## **CHRIS TEAM SUBDIVISION**

FINAL DRAINAGE REPORT

EL PASO COUNTY PROJECT NO: SF246

JANUARY 2025

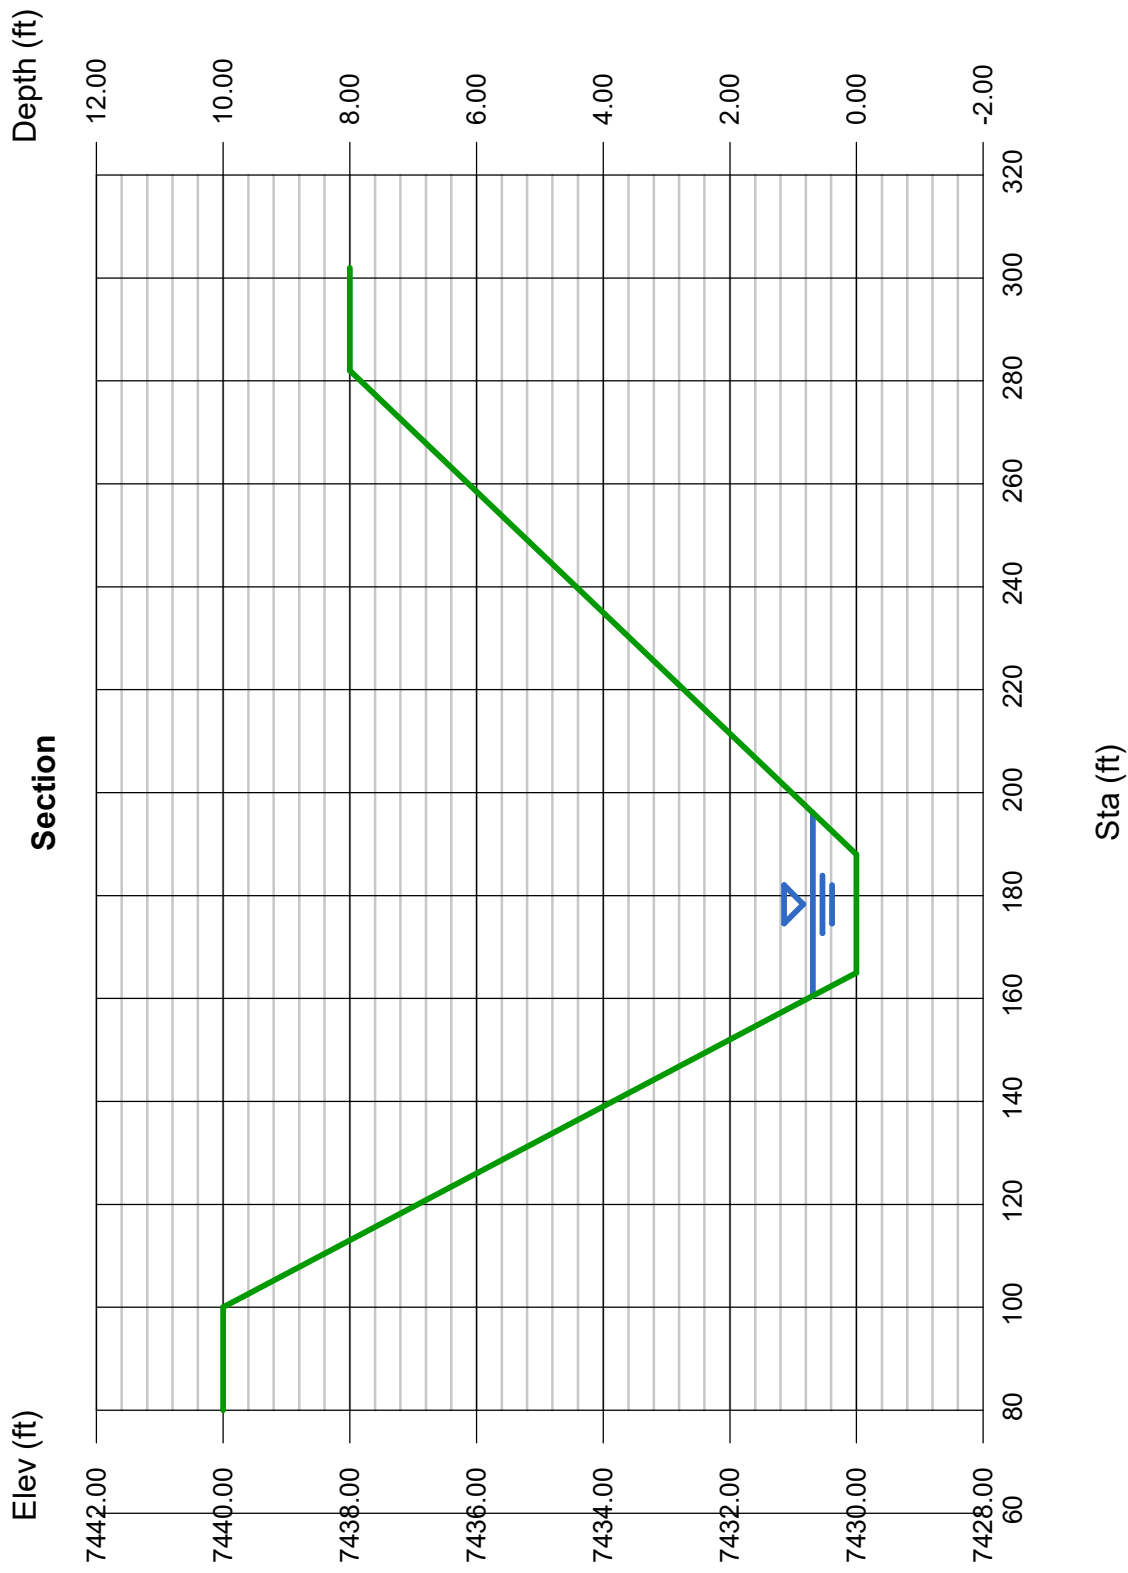
Please correct page orientation.

ALL TERRAIN RESPONSE:  
ADDRESSED.

EXISTING CONDITIONS DRAINAGE MAP	
CHRIS TEAM SUBDIVISION	
JOB NO. 24019	SHEET
LOCATION: EPC	1
11/29/2024

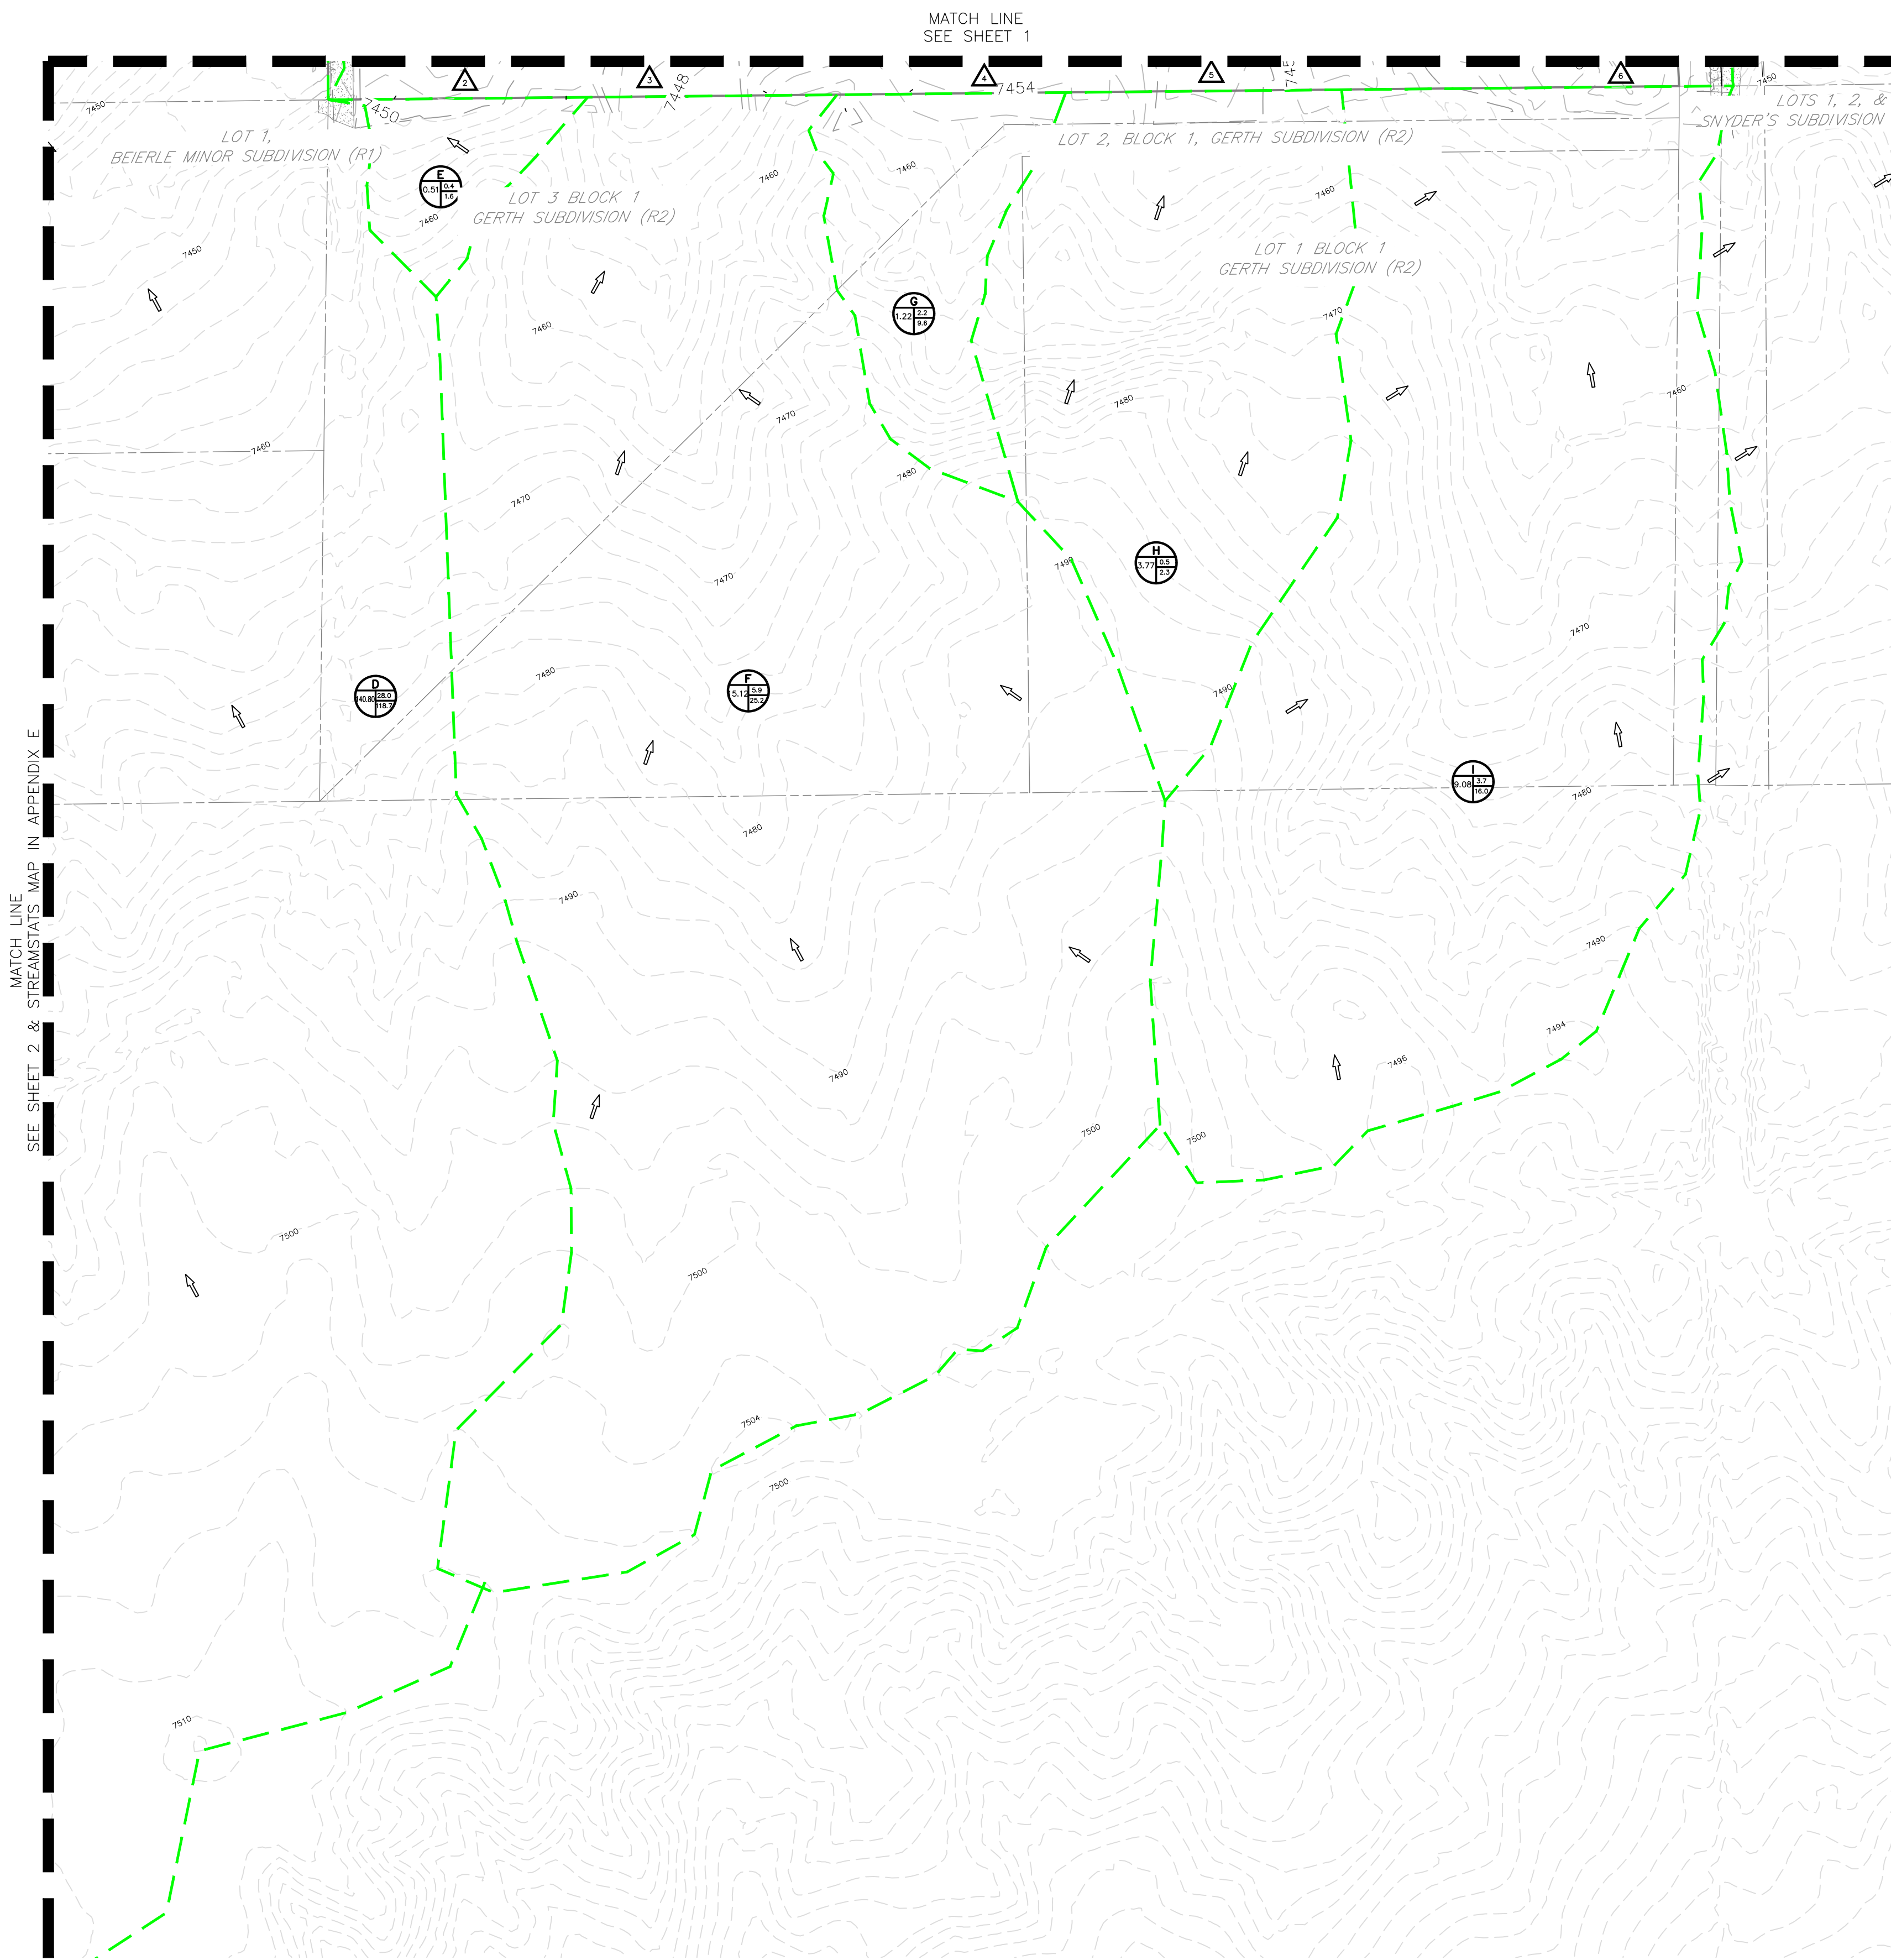
Provide discussion of this culvert in report.

Show and label 100-year ponding depth of flows here.

Basin should be separated at the drainage easement line with design points. These design points can then be added into the channel flow to result in a total flow outfalling offsite at DP7.

ALL TERRAIN RESPONSE ADDRESSED. SEE BASIN C DESCRIPTION. CULVERT CALC PRESENTED IN APPENDIX C.

ALL TERRAIN RESPONSE: OVERTOPPING LIMITS ADDED TO MAP.

ALL TERRAIN RESPONSE: PER ALL TERRAIN AND COUNTY MEETING ON 01/15, ADDITIONAL EXISTING DESIGN POINTS NOT REQUIRED. CUMULATIVE FLOW AT DP7 IS USED FOR ALL DRAINAGEWAY ANALYSIS, TO BE CONSERVATIVE.

EXISTING CONDITIONS DRAINAGE MAP	
CHRIS TEAM SUBDIVISION	
JOB NO: 24019	SHEET
LOCATION: EPC	2
11/29/2024

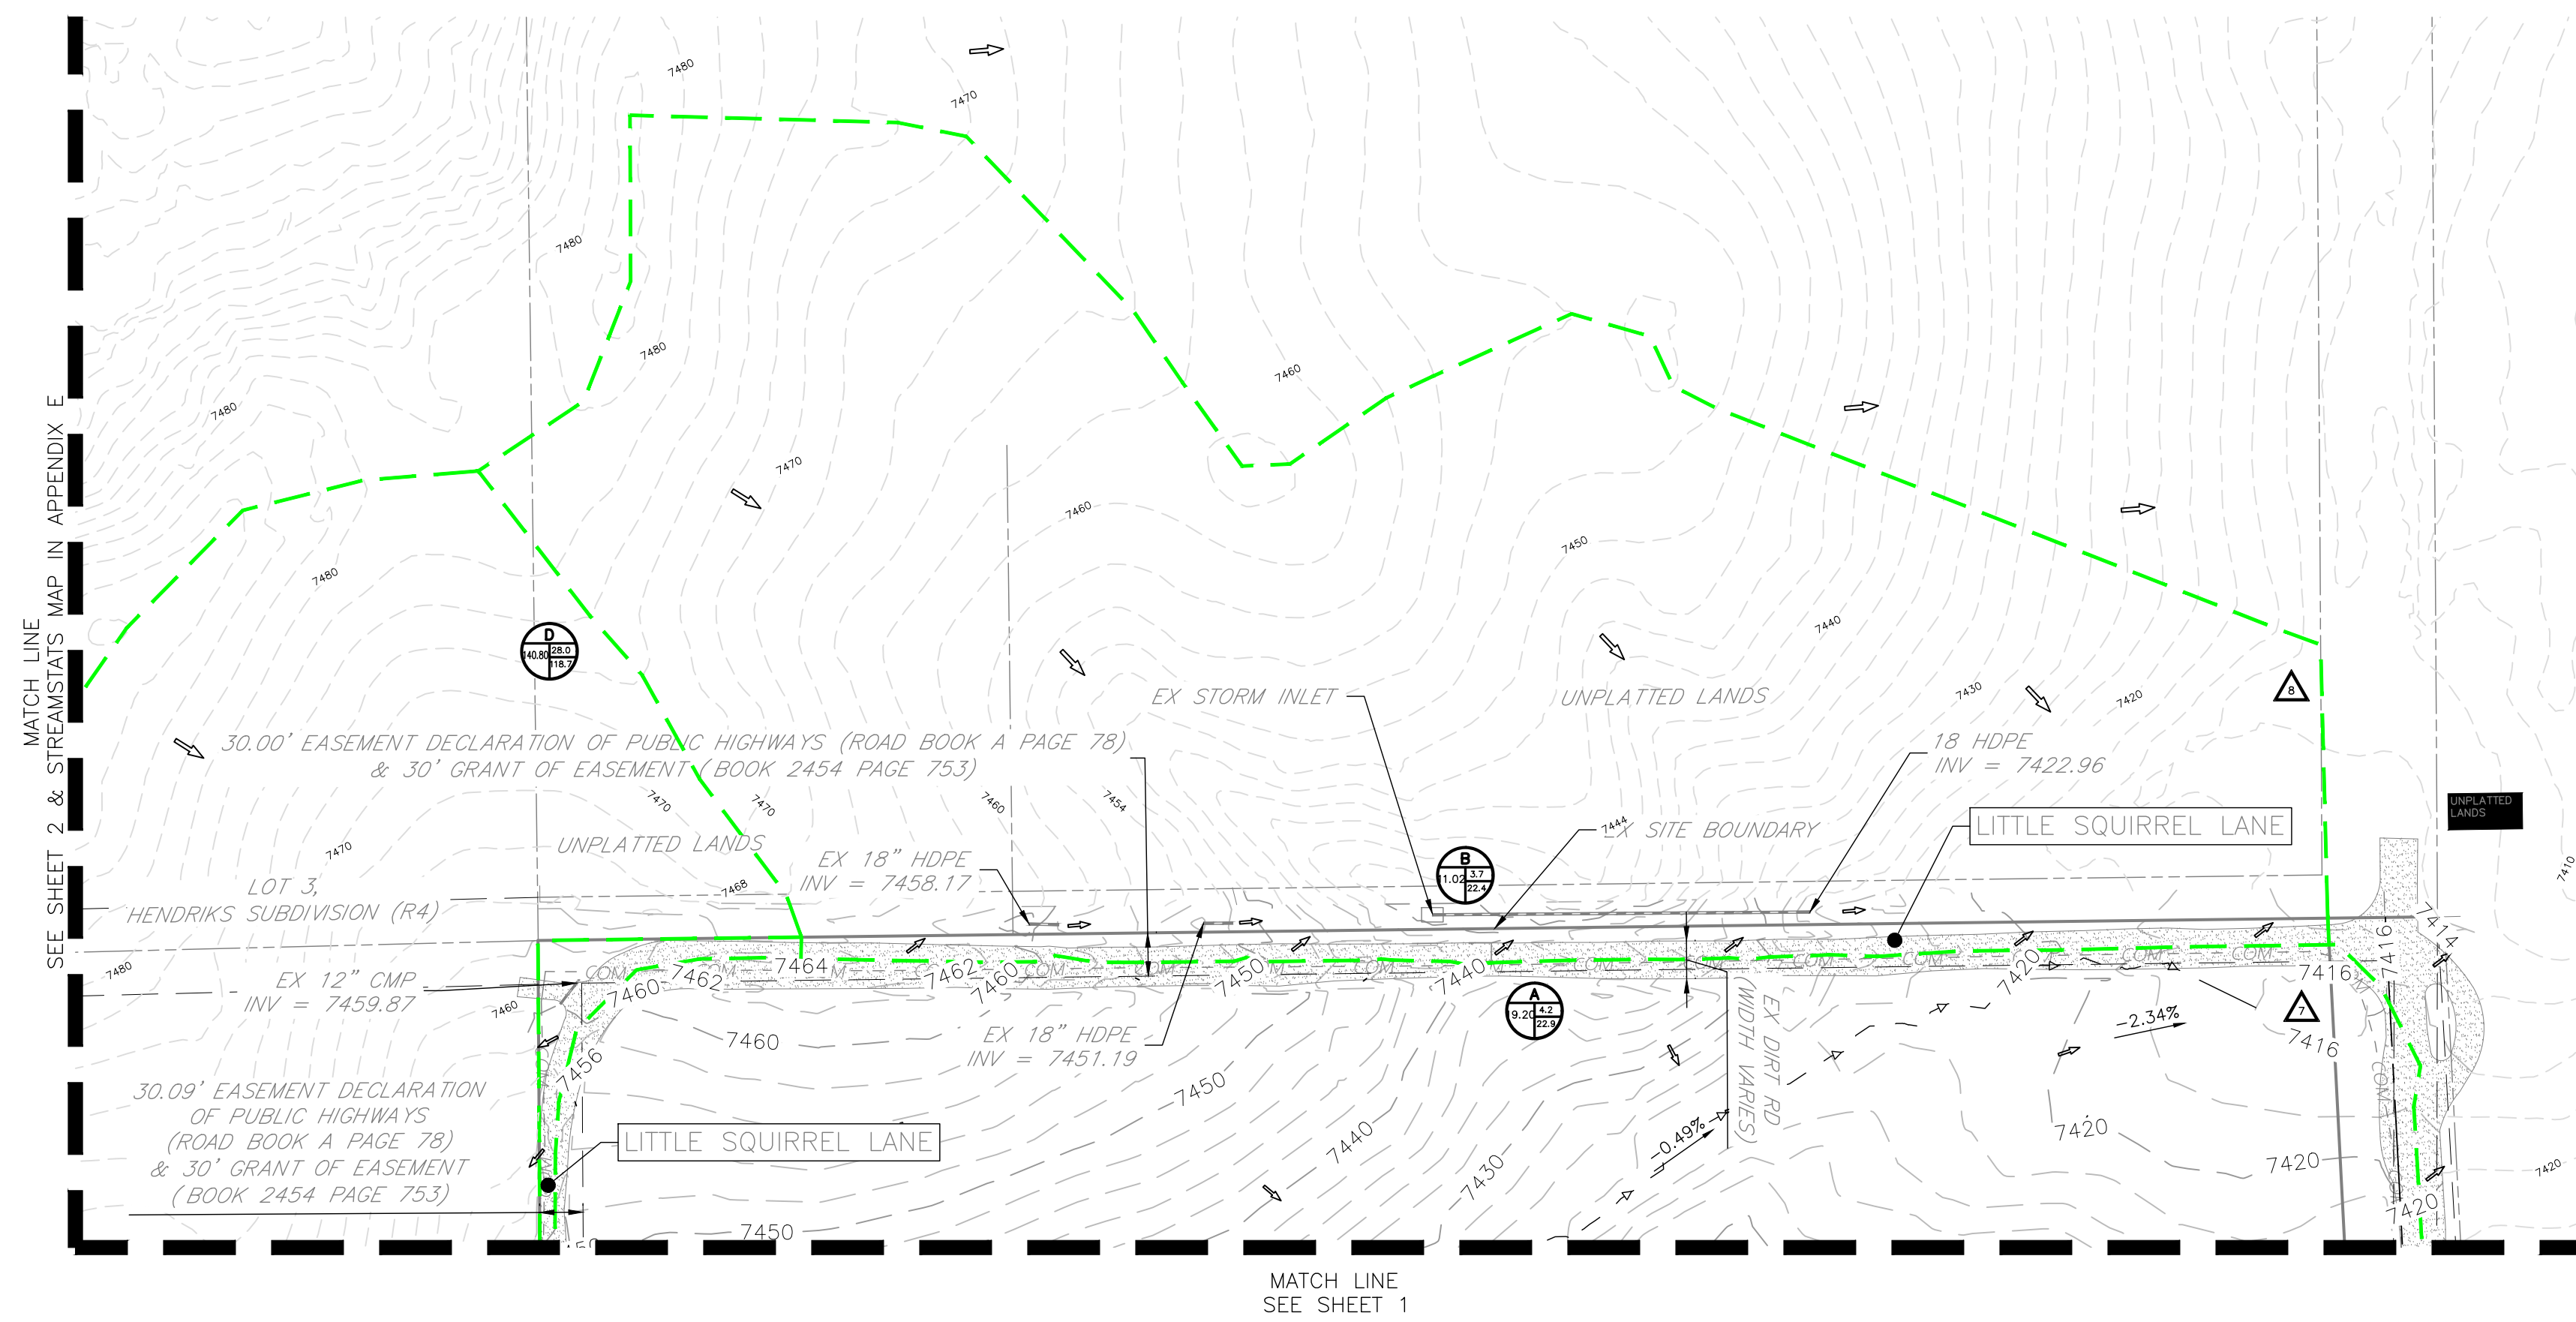
Sheet 3 please, for clarity.

ALL TERRAIN RESPONSE: ADDRESSED.
